BCA ASSESSMENT REPORT (DA)

114 Old Pittwater Road, Brookvale NSW

Project Number: 121095

Date: 17 December 2024

Figure 3 – New awning

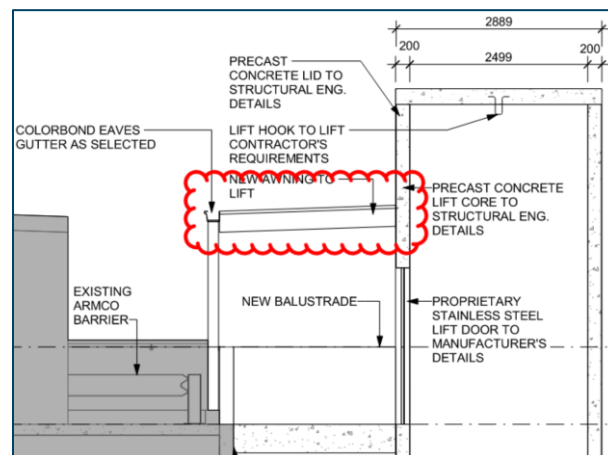
- + Subject to the required FRLs being provided for affected parts in accordance with **Annexure C** of this report, the proposed works are capable of complying with the requirements of the BCA2022 Specification 5 with respect to fire resistance.
- + Since the building is not sprinkler protected, the new awning roof structure and associated loadbearing external columns/posts are required to be fire-resisting in accordance with BCA Table S5C11g. Early input from a Fire Safety Engineer is recommended to determine whether the FRL can be omitted as part of a Performance Solution.
